From: Gilmore, Tyler J [Tyler.Gilmore@pnnl.gov]
Sent: Friday, January 17, 2014 4:06 PM
To: McDonald, Jeffrey
Cc: Greenhagen, Andrew
Subject: Re: Informal Request (IR) # 3 (IR3-01-10-14)
Attachments: EPA_IR3_for_FG-RPT-017-Final.pdf

From: <McDonald>, Jeff McDonald <mcdonald.jeffrey@epa.gov>
Date: Friday, January 10, 2014 12:38 PM
To: Tyler Gilmore <tyler.gilmore@pnnl.gov>
Cc: "Greenhagen, Andrew" <Greenhagen.Andrew@epa.gov>
Subject: Informal Request (IR) # 3 (IR3-01-10-14)

Determination of the Top of the Injection Zone, based on Geophysical Logs and Modeling Results

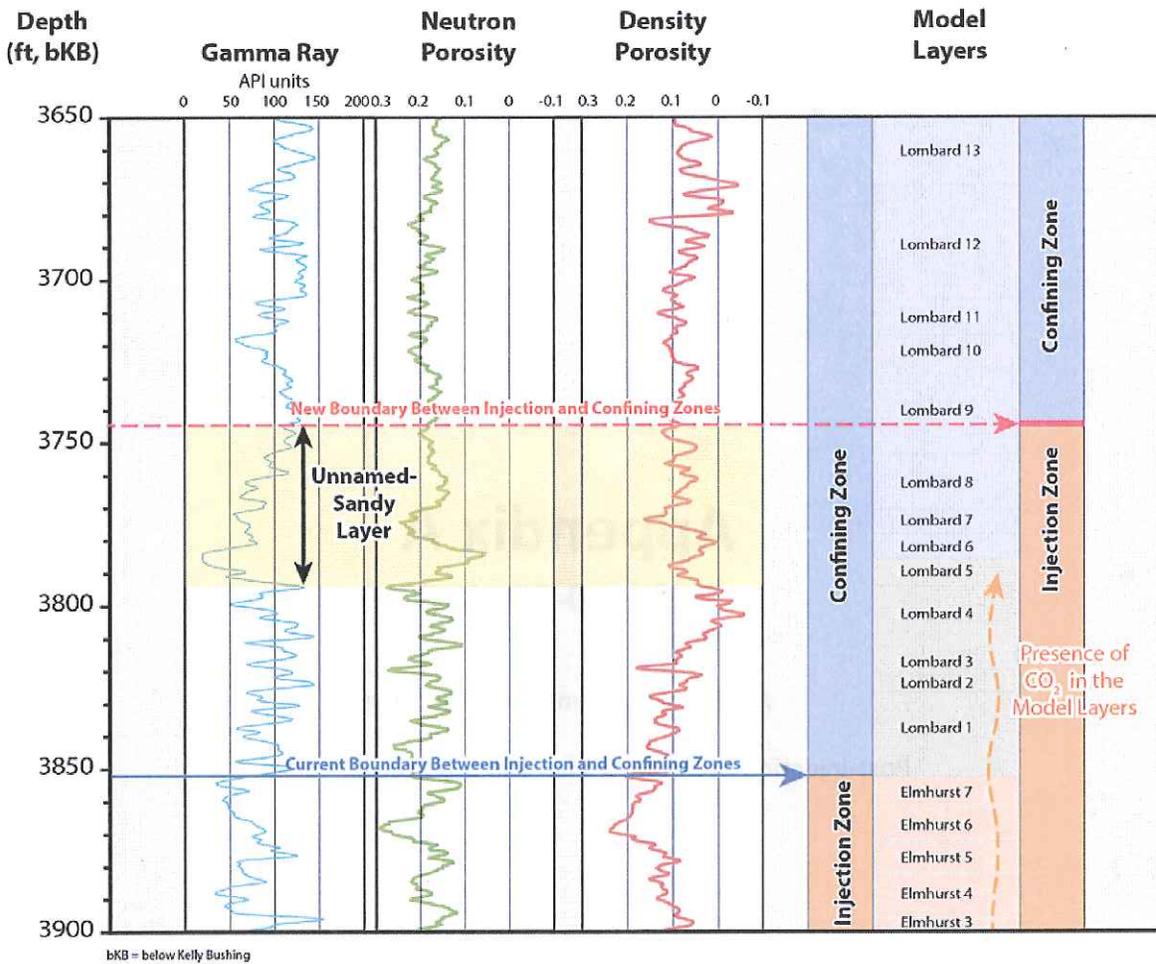
01-10-2014: Email from Jeff McDonald (U.S. EPA Region 5) to Tyler Gilmore (Alliance): "Informal Request (IR) #3 (IR3_01-10-14)"							
Requests based on the text application							
IR #	Subject	Page	Doc. Sec.	Par.	EPA Comment / Question / Request	FutureGen Response	Footnote / Reference Citation
01-10-2014_5	PISC	3.27 to 3.34	7.1.3 and 3.1.6		"The computational model results indicate that a small fraction of the injected CO2 will enter the lower part of the Lombard formation, if authorized under any UIC permits; the injection zone will need to include that lower part of the Lombard. Please determine what members or submembers of the Lombard are expected to receive CO2 and will therefore be part of any permitted injection zone."	The computation model results indicate that the Model Layer "Lombard 5" is the top unit containing a fraction of injected CO2 during the 100-year simulation. However, because geophysical logs indicate the presence of an unnamed thin sandy layer above Lombard 5 (see graphic in Appendix A), the Alliance determined that this thin sandstone should also be part of the injection zone. In conclusion, based on the current knowledge of the geology at the FGA1 stratigraphic well, the top of the injection zone is set at 3,745 ft bKB (or 3,731 ft below ground surface), which is in the lower part of the model layer "Lombard 9" (Appendix A) KB = below Kelly Bushing

Figure 2. Updated and Revised Plan for Monitoring Wells.

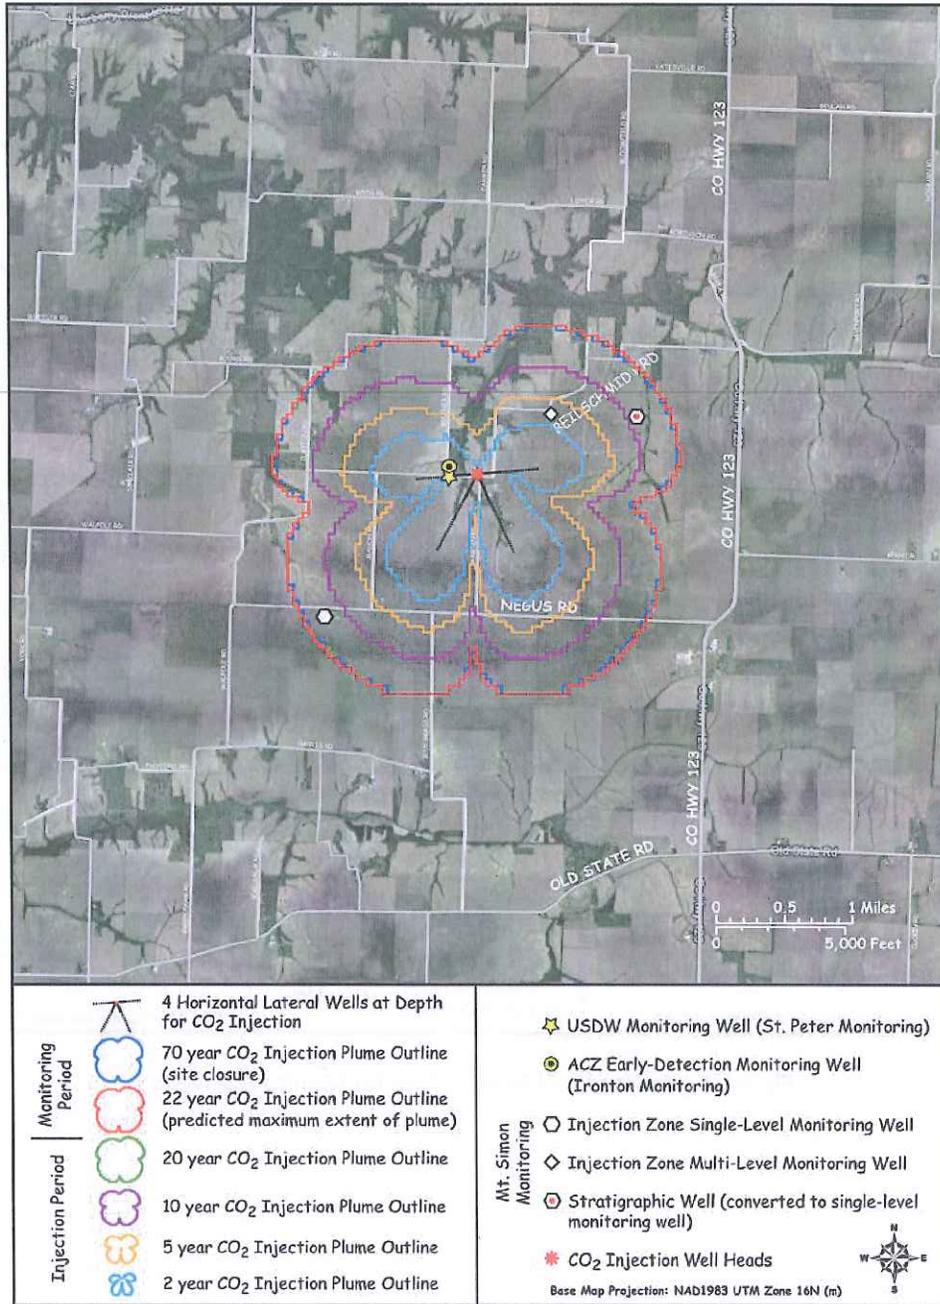
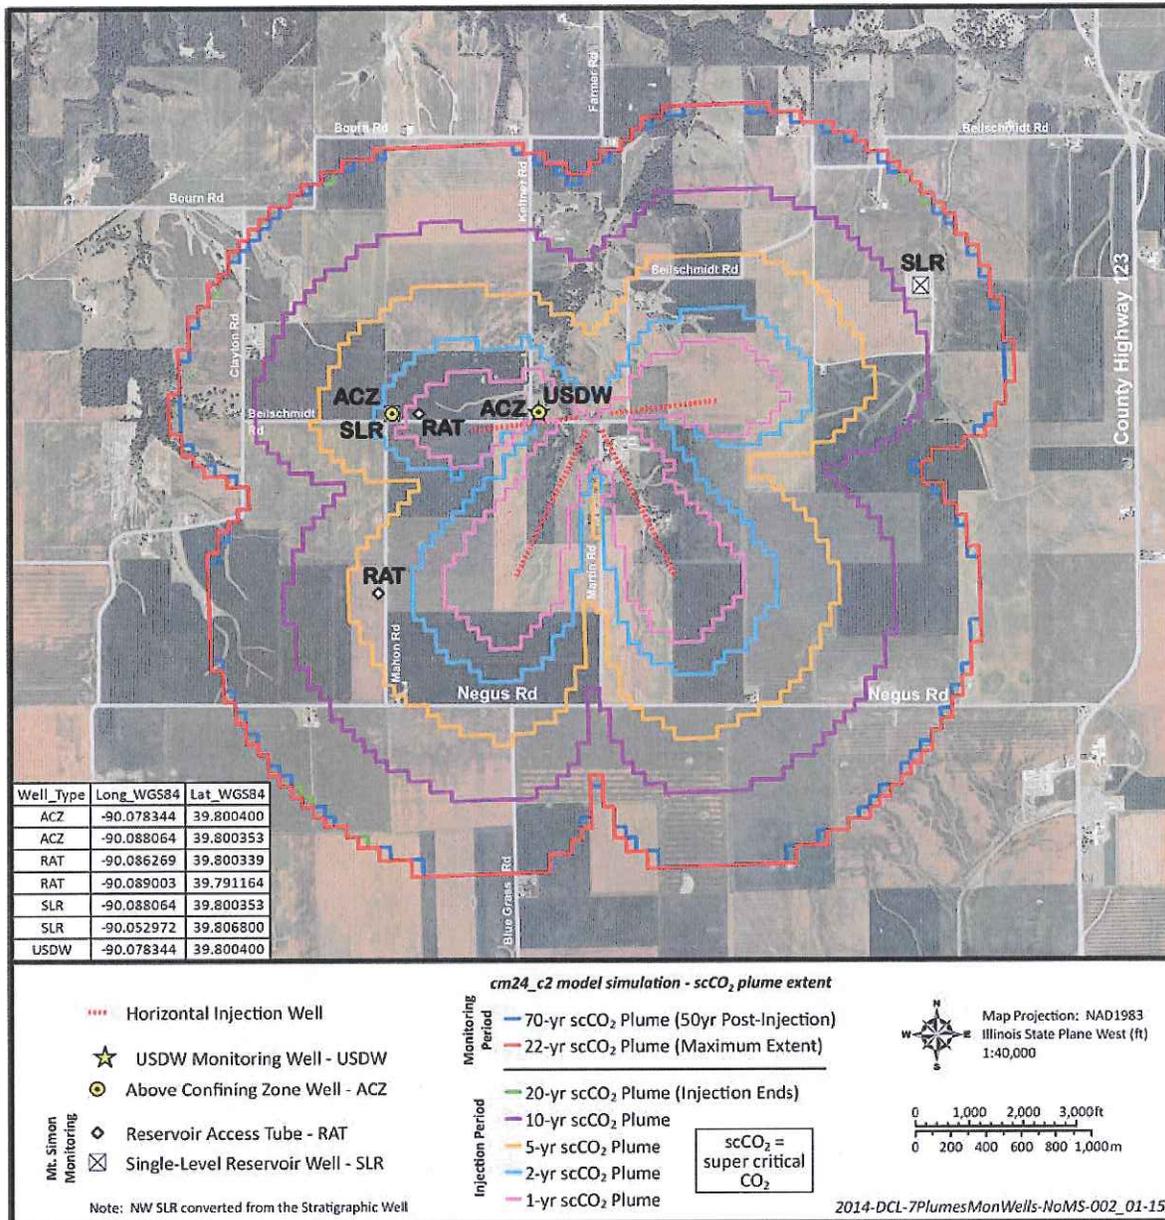
01-10-2014_6	PISC and T&M	7.5	7.2 and 5.2		"Specific locations of monitoring wells need to be identified for any permit decision including what specific parameters will be monitored for."	The Alliance has modified the monitoring network design since the UIC permit application was submitted. A discussion, which includes monitored parameters, and a location map showing the updated and revised monitoring well network are provided in Appendix B .	
01-10-2014_7	PISC and T&M	7.5	7.2.2		"Please state whether FGA will use a "multi-level monitoring system within a single casing string with multiple sample intervals," or a "multi-level piezometer installation."	The Alliance has modified the monitoring network design since the UIC permit application was submitted by eliminating this "multi-level monitoring well". The previously planned multi-level completion has been replaced by two fully cased reservoir access tubes (RATs) that will be installed within the boundaries of the simulated 5-year CO2 plume. The RATs will extend to the base of the reservoir and into the Precambrian bedrock. The RATs will be non-perforated, cemented casings used to monitor CO2 arrival and quantify saturation levels via downhole pulsed-neutron capture (PNC) geophysical logging across the reservoir and confining zone.

The monitoring well network (Figure 1) has been updated in accordance with discussion in the UIC application supporting documentation.

As part of the project's design optimization, the monitoring well network design has been revised (Figure 2) to increase its effectiveness, simplify its engineering design, and hopefully eliminate any permitting challenges that might have been associated with the MLR. The revisions include eliminating the MLR well in favor of adding two fully cased reservoir access tube (RAT) wells. The revised design includes a total of seven monitoring wells summarized in Table 1 and as follows:
